Evaluation of the Tailings Storage Facility for the Proposed Savannah Lithium Barroso Mine, Northern Portugal

Report prepared at the request of Povo e Natureza do Barroso
Submitted on June 6, 2021, Revised on June 10, 15 and 29, 2021

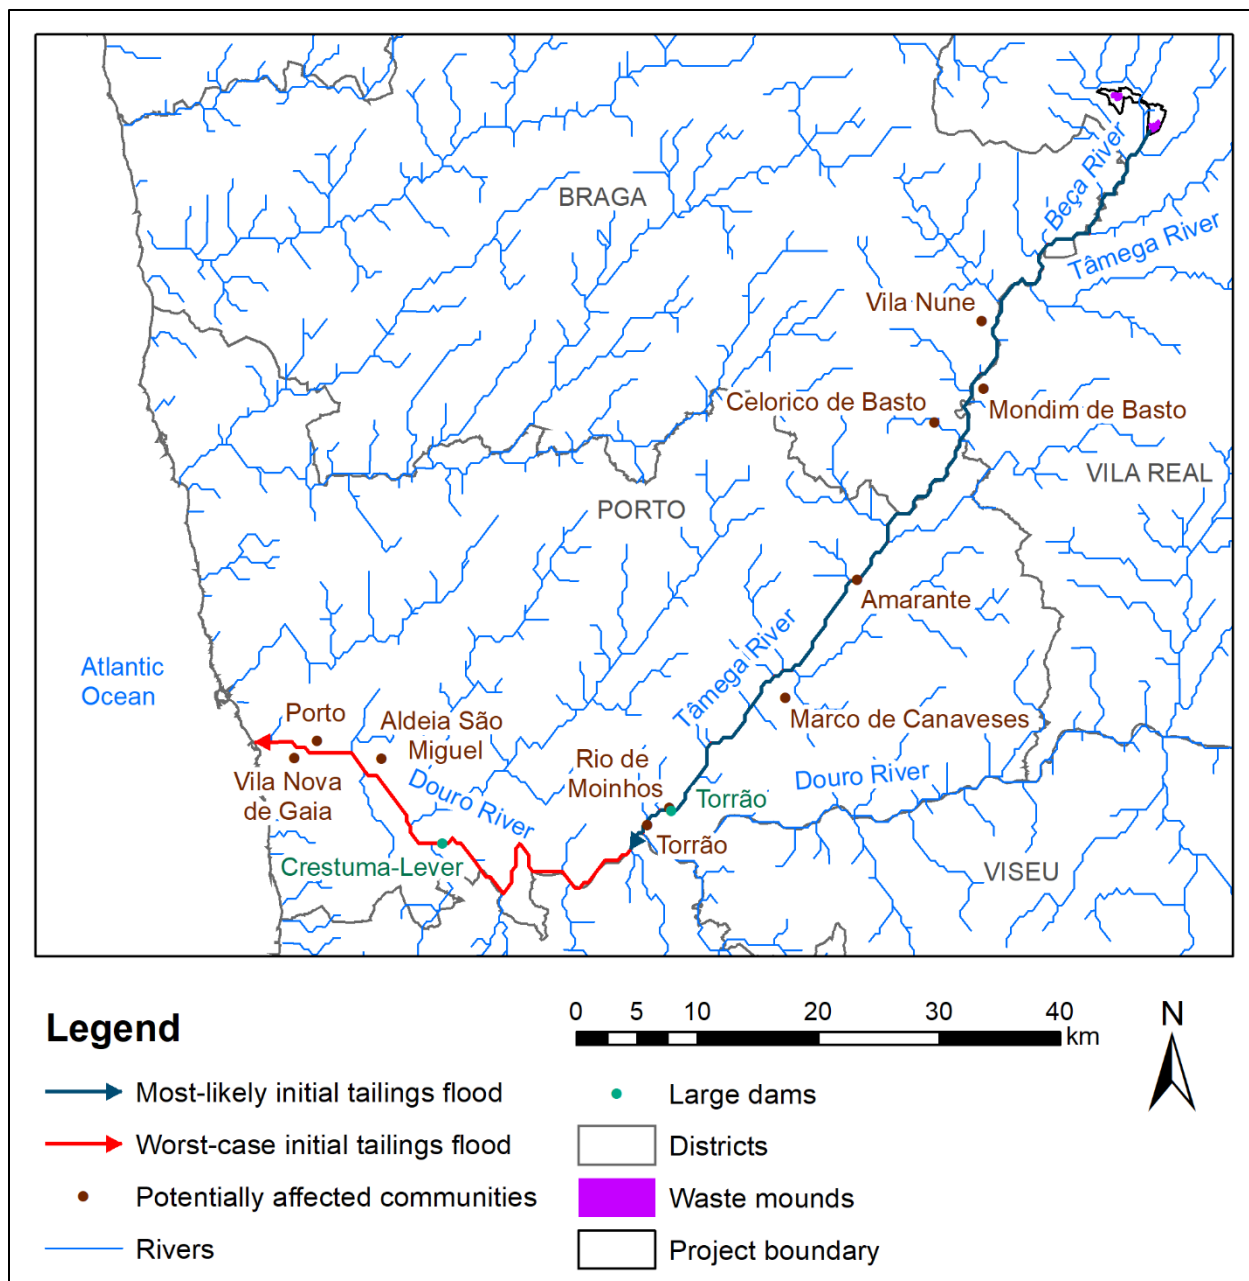
Based on the statistical model by Larrauri and Lall (2018), the most-likely prediction is that the initial flow of tailings will extend for 59.9, 83.7 and 86.1 kilometers for Alternatives 1, 2 and 3, respectively (see Table 1). Based on the preferred Alternative 3, in the initial event, the spilled tailings will flow along the Beça River to the Tâmega River and down to the confluence with the Douro River with the potential of impacting numerous communities along the rivers, including (in downstream order) Vila Nune, Mondim de Basto, Celorico de Basto, Amarante, Marco de Canaveses, Rio de Moinhos, and Torrão (see Fig. 2). Following the initial event, normal fluvial processes will continue to transport the spilled tailings along the Douro River past the communities of Aldeia São Miguel, Porto and Vila Nova de Gaia to the Atlantic Ocean (see

Using the same statistical model (Larrauri and Lall, 2018), the most-likely predictions for the volumes of spilled mine waste are 5.6, 8.1, and 8.5 million cubic meters for Alternatives 1, 2 and 3, respectively (see Table 1), corresponding to 28-29% of the stored mine waste. The worst-case scenario will be the release of 100% of the stored mine waste (19.4, 28.9, and 30.5 million cubic meters for Alternatives 1, 2 and 3, respectively; see Table 1). In this case, according to Eqs. (3)-(4), in the initial event, the spilled tailings will travel for 234.1, 334.5 and 344.9 kilometers for Alternatives 1, 2 and 3, respectively (see Table 1). However, in the worst-case scenario, the actual initial event will be limited by the 128-kilometer distance to the Atlantic Ocean (see Fig. 2).

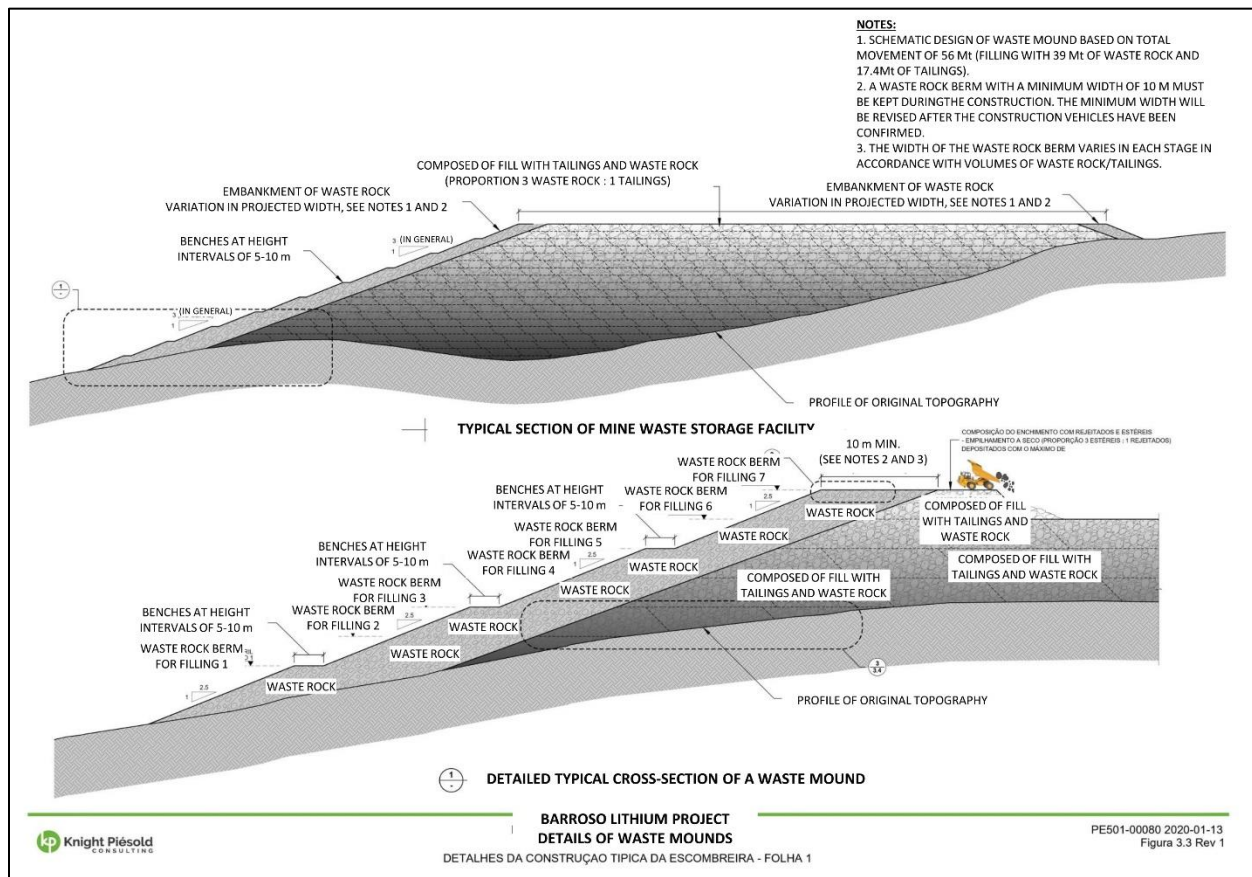
Figure 8. Although Savannah Lithium LDA (2020a-f) never uses the word “dam,” the embankment of waste rock that would confine the mixture of waste rock and filtered tailings serves the function of a dam and should be designed to meet dam safety regulations. The above is especially true because, based on current filtered tailings technology and occasional high precipitation, a significant proportion of the tailings will be too wet for adequate compaction. The waste rock dam would be constructed using the upstream method, in which the dam is built on top of the tailings that it is confining. In the event of the liquefaction of the tailings, the dam will collapse into the underlying tailings. For that reason, the method of upstream construction is illegal in Brazil, Chile, Ecuador and Peru. Figure from Savannah Lithium LDA (2020b) with overlay of English labels.

- 4) The proposal does not recognize that the embankment of waste rock that would surround the mixture of filtered tailings and waste rock constitutes a dam and should conform to dam safety standards. In particular, there is no design flood for the dam, although the dam should be able to withstand a 500-year flood according to dam safety law in Portugal and at least a 1000-year flood by most international standards.

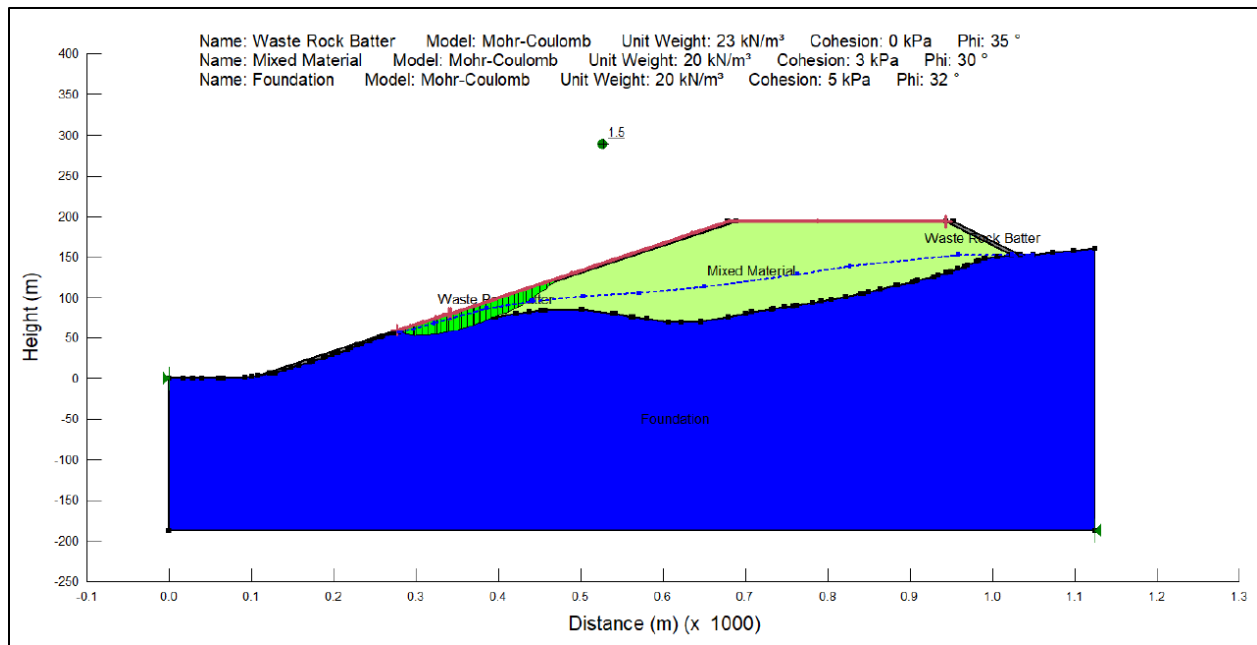
The stability analysis yielded a factor of safety FS for resistance against sliding without liquefaction of $FS = 1.5$ (see Figs. 9a-b), which is the minimum acceptable factor of safety according to most international standards (e.g., ANCOLD, 2012; Canadian Dam Association, 2013, 2019). The factor of safety was calculated based on assumed shear strength parameters (cohesion and friction angle) of the tailings (see Figs. 9a-b), so that, presumably, lower shear strength parameters would result in a factor of safety $FS < 1.5$, which would be unacceptably low. The shear strength parameters of the tailings were estimated based on the drained condition (see Fig. 9a), meaning that water is free to escape from the pores during shearing or other deformation. Testing under the undrained condition means that the sample is sealed so that water cannot escape during deformation of the sample. The undrained shear strength parameters are nearly always lower than the drained shear strength parameters, and thus nearly always produce a lower factor of safety. The undrained shear strength parameters are typically relevant for field situations in which the pores are saturated and/or the tailings have low permeability. The assumption that the pores would be unsaturated during field loading was not accompanied with

The calculation of the factor of safety was finally based on an assumed water table height, so that, presumably, a higher water table would result in a factor of safety FS < 1.5, which would again be unacceptably low (see Fig. 9b). However, the stability analysis included no justification for the assumed water table height. There was also no consideration of the dependence of the factor of safety on the height of the water table nor a consideration of the circumstances under which the water table would rise higher than the assumed height. It should be noted that high water tables could result from any combination of excessive water in the tailings, precipitation onto the waste mound, surface runoff onto the waste mound, or upward seepage of groundwater into the waste mound. In summary, in light of its numerous unjustified assumptions, the stability analysis cannot be regarded as reliable. In fact, the final calculation of FS = 1.5 based upon unjustified input data suggests that the input data were chosen only to guarantee that the factor of safety would be the minimum acceptable value.

- 7) Although the stability analysis indicated a minimum acceptable factor of safety $FS = 1.5$, the shear strength parameters of the tailings were determined from only one sample and were not actually measured, but estimated from the grain size distribution. Moreover, the stability analysis assumed the “drained” loading condition with no consideration of the circumstances under which the pores would be saturated. In addition, there is no document that describes any geotechnical testing of the waste rock or foundation, nor is there any document that explains how the shear strength parameters of the waste rock and foundation were estimated. Finally, the stability analysis included no justification for the assumed water table height, and no consideration of the dependence of the factor of safety on the height of the water table or the circumstances under which the water table would rise higher than the assumed height.

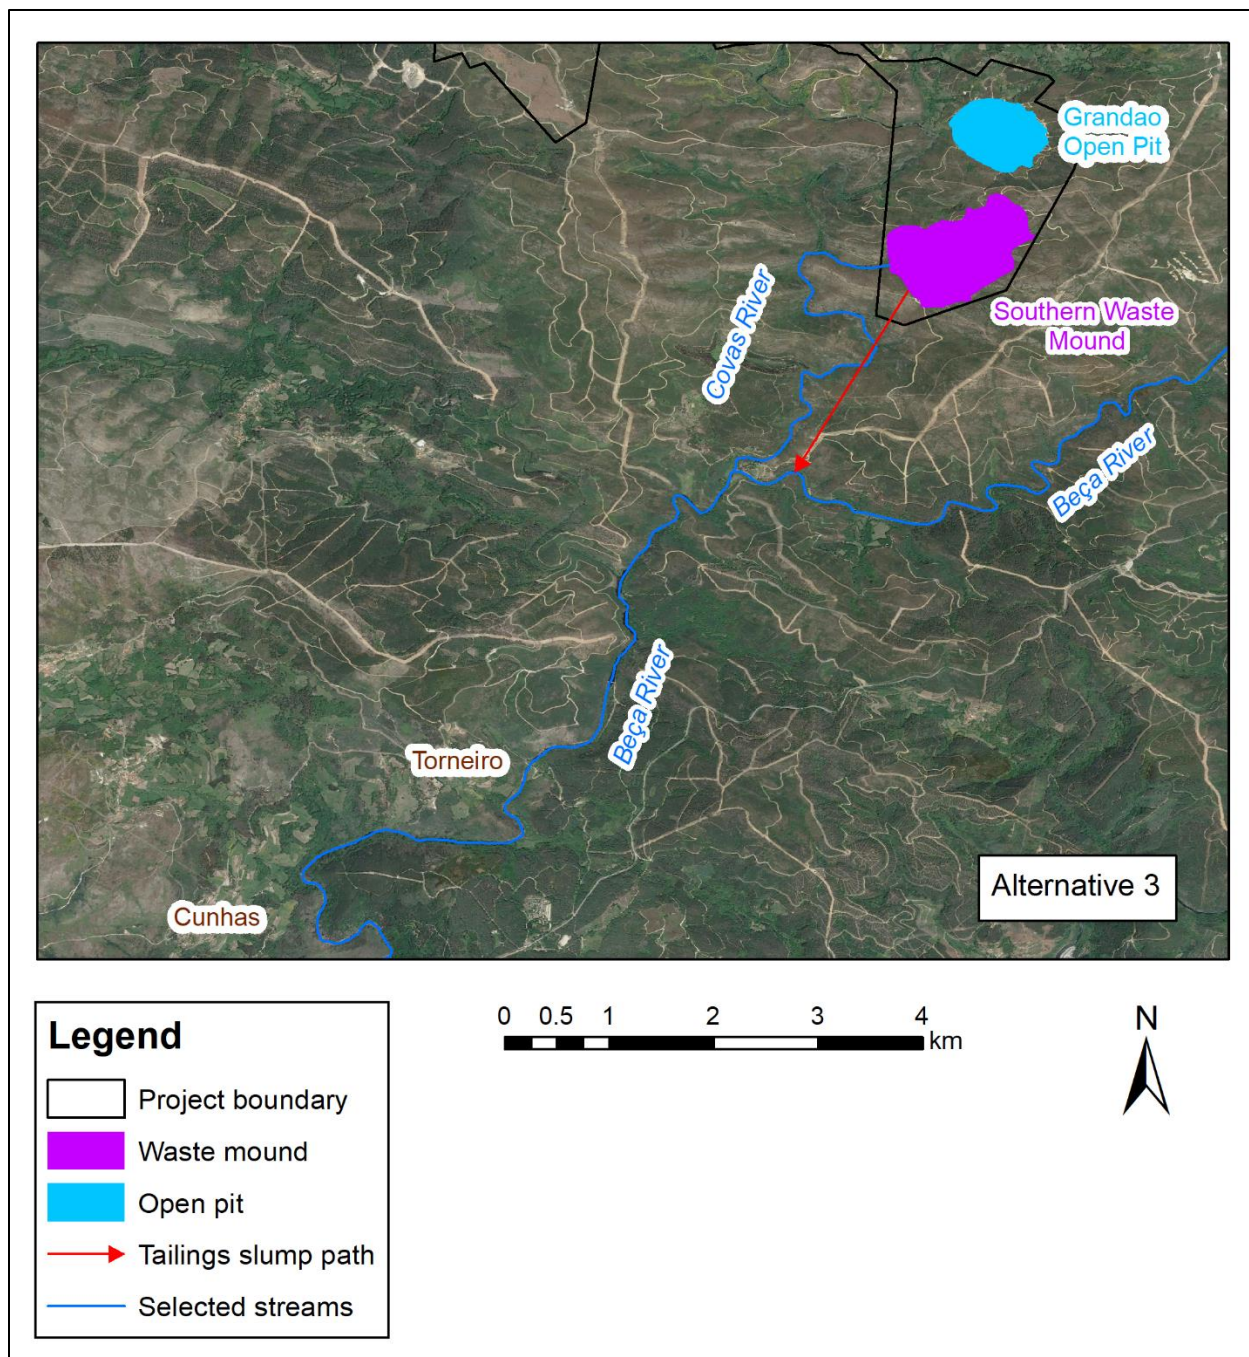
Figure 10. There are two communities (Torneiro and Cunhas) within 10 kilometers downstream of the tailings dam along the course of the flow path (see Table 3). It is assumed that the tailings flood will travel in a straight line in a general downstream direction (called the tailings slump path) until reaching the Beça River, after which it will flow downstream along the Beça River. In Brazilian and Ecuadorian legislation, the “self-rescue zone” is defined as 10 kilometers downstream of the tailings dam along the course of the valley or the region that can be reached by the tailings flood in 30 minutes, whichever is farther. In Brazil and Ecuador, it is prohibited to construct or expand a tailings dam where there is a population residing within the self-rescue zone. Mine infrastructure based on Alternative 3 from Savannah Lithium LDA (2020g). Background and community locations are from Google Earth images from May 5 and May 24, 2019.

There are two communities (Torneiro and Cunhas) within 10 kilometers downstream of the tailings dam along the course of the flow path (see Table 3 and Fig. 10), not including isolated farmhouses. It is assumed that the tailings flood will travel in a straight line in a general downstream direction (called the tailings slump path in Fig. 10) until reaching the Beça River, after which it will flow downstream along the Beça River. Based on the minimum tailings flow velocity of 20 kilometers per hour, the tailings flood will reach Torneiro and Cunhas in a maximum of 19 and 28 minutes, respectively (see Table 3). However, based on presently available information, it is not obvious whether there would be potential loss of life in the event of failure of the waste mound. Due to the rugged topography, the average elevations of Torneiro and Cunhas are, respectively, 99 and 170 meters above the Beça River (see Table 3). A rigorous study would be required to determine whether the three communities within 10 kilometers of the Southern Waste Mound (see Fig. 10) or any of the communities even farther downstream (see Fig. 2) could be or should be evacuated prior to arrival of the tailings flood. However, it should be noted that the Environmental Impact Study does not include any consideration of an alarm system for the downstream communities or any other emergency plan of any kind.

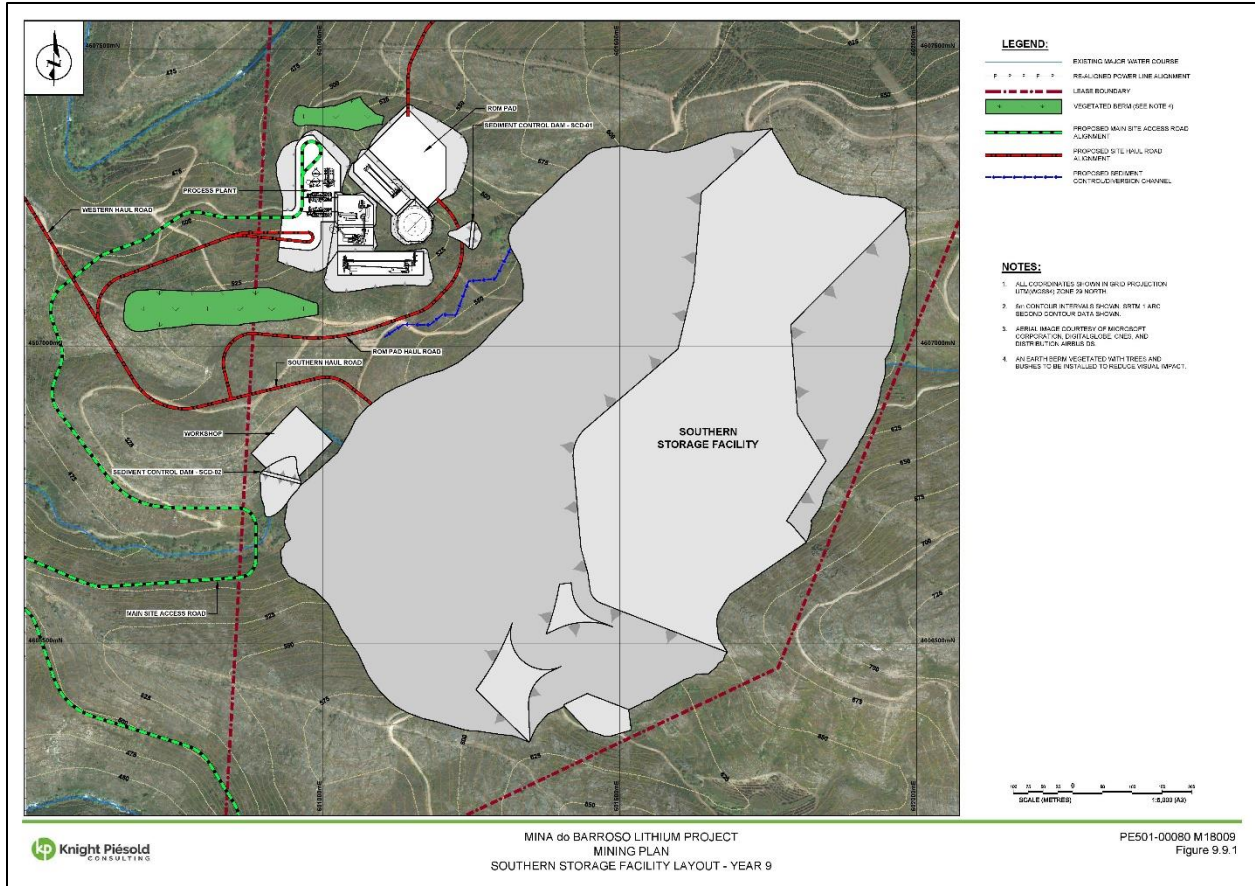
Figure 12. The figure clarifies that an existing stream flows through the site of the planned Southern Waste Mound (also called Southern Storage Facility), entering from the eastern side and exiting on the western side. There is no apparent plan for any water management infrastructure that would convey the stream and other surface runoff around the waste mound so as to prevent rewetting of the tailings. The outline of the Southern Waste Mound corresponds to Alternative 3 (see Table 1 and Fig. 4c). The figure was taken from Savannah Lithium LDA (2020d) and is available only in English.

return period) that the water management infrastructure should be able to accommodate. According to the Environmental Impact Study, the existence of a water management infrastructure was an assumption underlying the calculation of the factor of safety. Savannah Lithium LDA (2020a) writes, *Foram tidos em conta os seguintes pressupostos para a modelação de estabilidade ... A drenagem superficial será instalada para desviar a água superficial para longe das estruturas e a sub-drenagem será construída para manter os níveis freáticos baixos*” [The following assumptions were taken into account for stability modeling: ... Surface drainage will be installed to divert surface water away from structures and sub-drainage will be constructed to keep groundwater levels low]. However, there is essentially no other discussion of the water management infrastructure for the waste mound so that is not even clear that there is any plan to construct water management infrastructure, besides the simple statement of an intention. For example, Savannah Lithium LDA (2020d) confirms that a stream would enter the east side of the Southern Waste Mound and exit from the west side (see Fig. 12 and compare with Figs. 4a-c). The superposition of the outline of the Southern Waste Mound on the satellite imagery shows a network of streams on the site of the proposed waste mound with streams entering from both the eastern and southern sides (see Fig. 13). However, there are no diagrams for diversionary canals that would convey either stream flow or surface runoff around the Southern Waste Mound, although the available diagrams indicate sediment control diversion canals and sediment check dams (see Fig. 12). Moreover, the Environmental Impact Study does not discuss nor show any diagrams for overdrains (channels that would be placed on top of a liner to convey water draining from the tailings pile) or underdrains (channels constructed under a liner for the conveyance of groundwater). There is also no mention of a liner that would prevent the exchange of water (in either direction) between the tailings pile and the underlying soil.

- 8) Although satellite images and the proposal itself show a stream network that flows through the site of the waste mound, there is no apparent plan for any water management infrastructure that would prevent rewetting of the tailings by stream flow, surface runoff or groundwater.
